Model: KP-53HS10, KP-53XBR300
KP-61HS10, KP-61XBR300**No. 511****Subject:** Picture distortion occurs when connected to
Star Choice (HDD-201) satellite receiver.**Date:** December 6, 2000**Symptom:**
(132X)

Picture of symptom on screen:

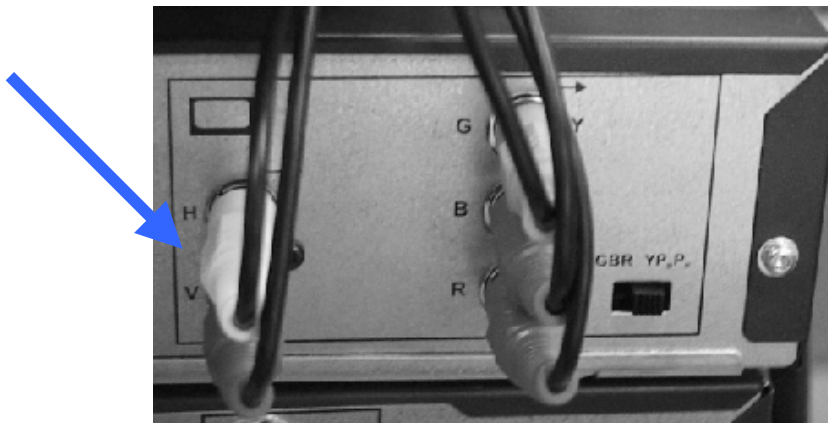
Topside of the picture is distorted in 1080i/480p when connected to Star Choice satellite receiver into the projection TV's Video 5 input. This symptom will only occur in a component Y, Pb, Pr configuration.

The HDD201 has non-standard sync pulses on the Y output signal during the vertical blanking time. These pulses effect the TV's video processing resulting in picture distortions.

For both Y, Pb, Pr and RGB connection configurations, a separate H & V Sync connection cable must be used between the satellite receiver and the video 5 input on the TV. In order to correct this symptom, a standard type RCA audio patch cable may be used. (See photos below.)
